Addendum No. 02

File Reference Number: RFP 2025 088

Title: Purchase of Nine (9) New Highway Motor Coaches

RE: Clarifications/Questions

Surveillance Camera Schematic Layout

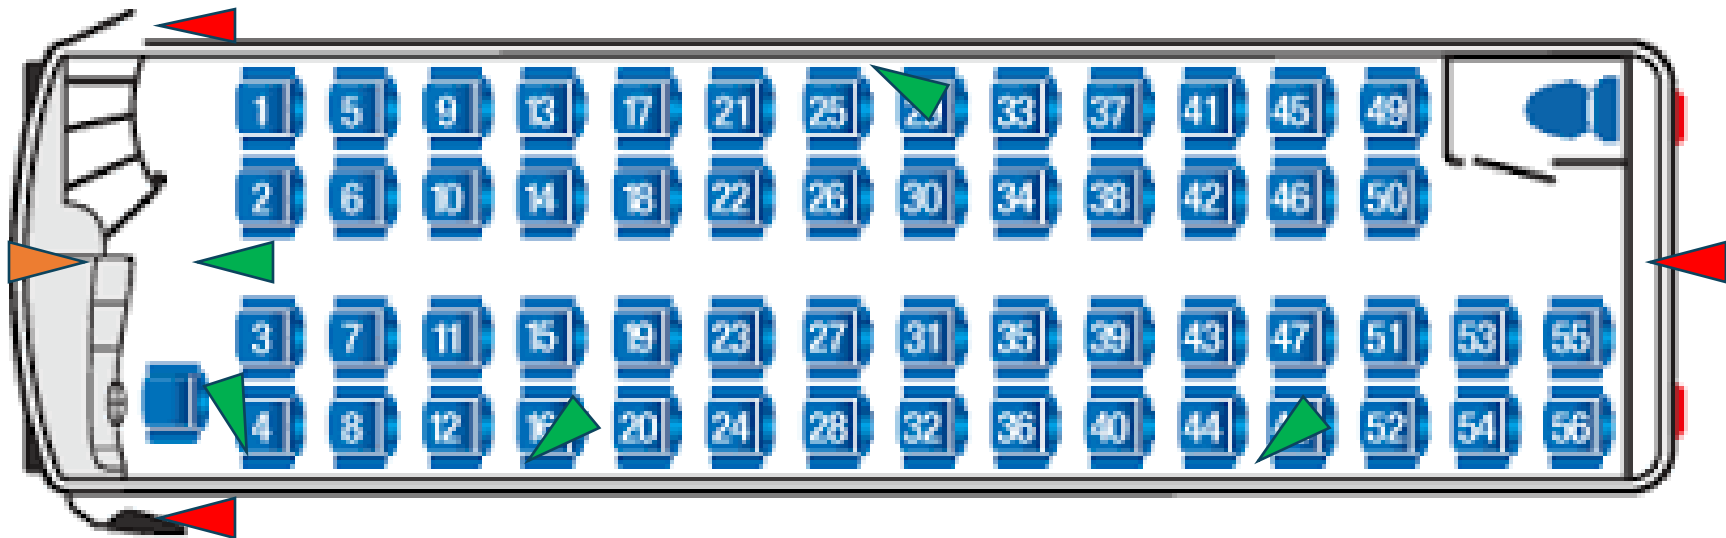
- a) **Camera system installation** - Would ONTC please specify the number of cameras and their positions?
- b) **Decals** - Would ONTC please specify quantity and placement?
- c) **Wi-Fi Internet** - Would ONTC please specify models and number of antennas?
- d) **Litter bag mounts** - Would ONTC please specify quantity and placement?

- a) **Camera System Installation** - ONTC advises there are three (3) exterior and six (6) interior cameras, which includes one (1) front facing camera. Please see diagram attached to this Addendum.
- b) **Decals** - ONTC advises there is one decal and ONTC will affix to the coaches upon delivery
- c) **Wi-Fi Internet** - ONTC advises that Product #Rx6S0007 is required, and the number of antennas required are as follows: two (2) exterior and one (1) interior antennas)
- d) **Litter bag mounts** - ONTC advises that one (1) litter bag mount installed on the side wall for every row of seating is required.

Note: Camera position may vary from coach to coach depending on seat capacity and location of wheelchair placement.
